Environmental
Protection Agency

**Re: Notice of Violation
Gender Road Improvements, Franklin County
Construction Storm Water Permit 4GC03485*AG**

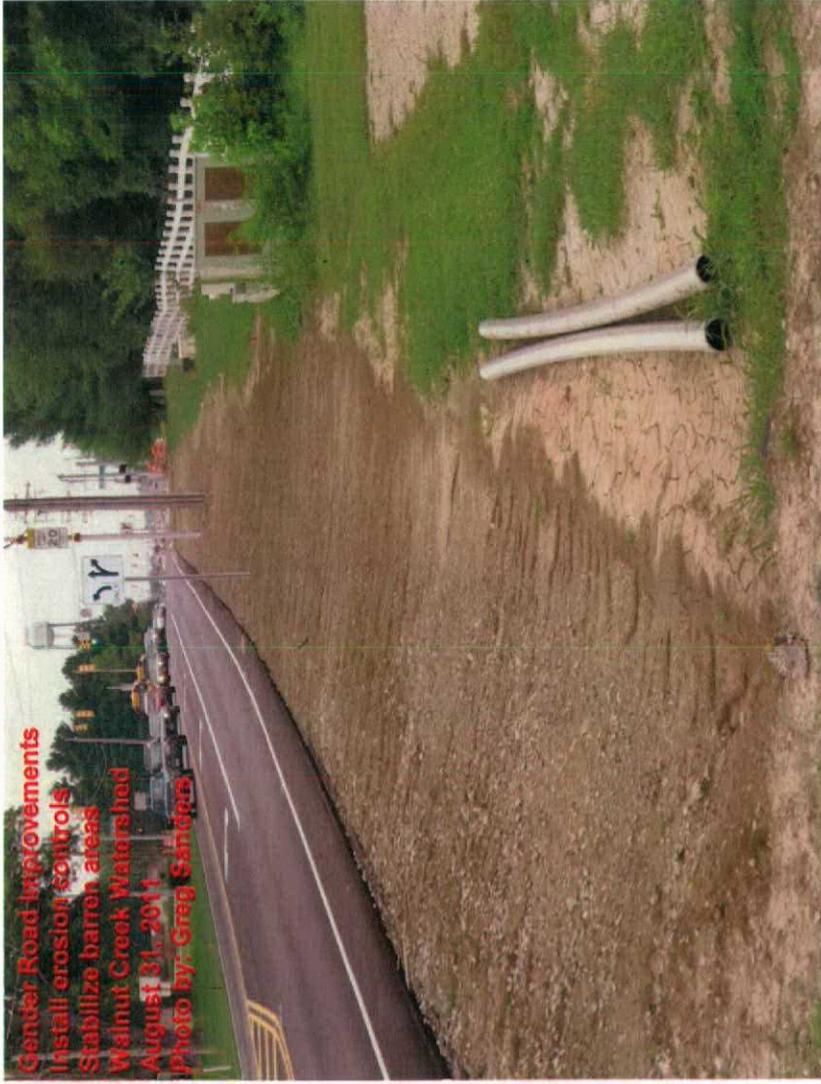
Gender Road Improvements
Install and maintain erosion controls
Stabilize barren areas
Walnut Creek Watershed
August 31, 2011
Photo by: Greg Sandofe
